File Number: 2017/136396

Our Ref: R/2015/33/A

State Significant Development Application SSD 7246: Foreshore and Public Domain Works at Campbell's Cove, The Rocks

Figure 1: Outdoor dining proposed within the new Custom Officer's Stair. The City recommends that all outdoor dining be removed from the plans. Tables and chairs in the area outlined in red must not be approved under any circumstances.

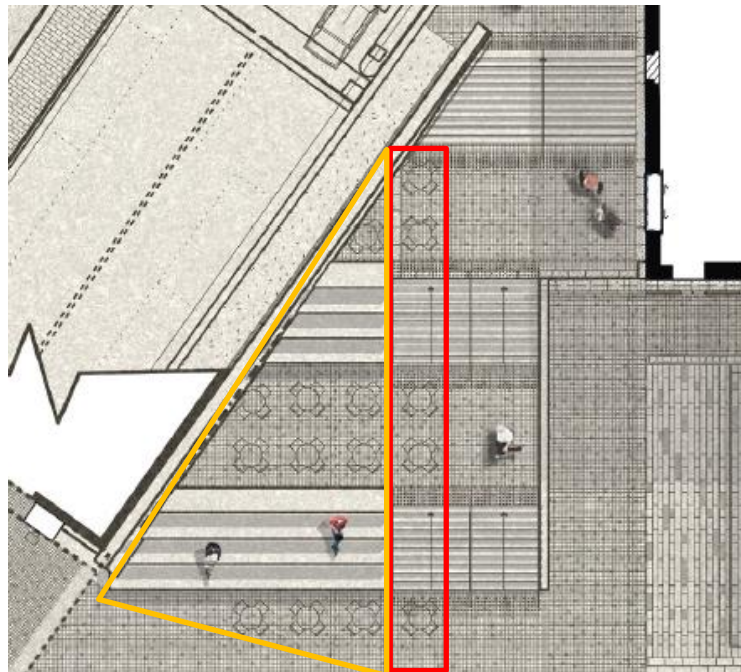
As illustrated in Figure 1 below, outdoor dining is proposed to be situated with the new Custom Officer's Stairs. This is not supported, as it privatises what should be an inherently public space. Tables and chairs positioned between the main stair rises are clearly inappropriate and must be deleted from the plans to ensure pedestrian flows are not encumbered in any way.
